Access Compliance Report Public Rights-of-Way (Curb Ramps)

Main Street: OAK_WAY_DR Cross Street: TIGERTAIL_DR Location: NE

ADA ID: RPRK211208111319 Ramp Type: Type 1 - Perpendicular Diagonal Initial Pass/Fail: Pass Overall Compliance: No Severity Score: 20

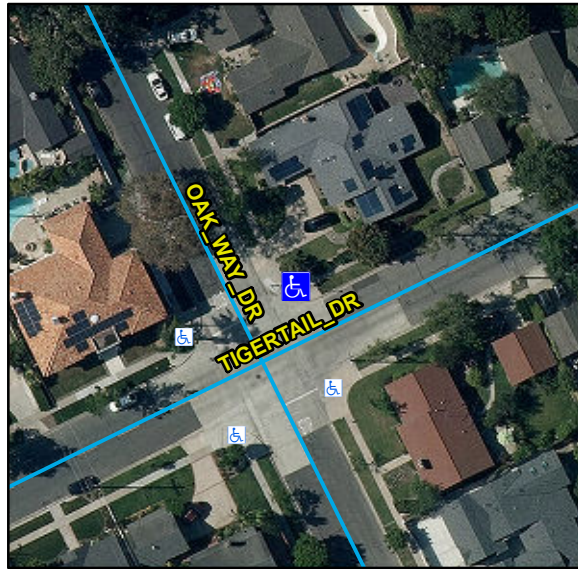
Possible Solutions:

Remove & Replace Curb Ramp With Two New Directional Ramps or Equivalent. Remove & Replace Gutter.
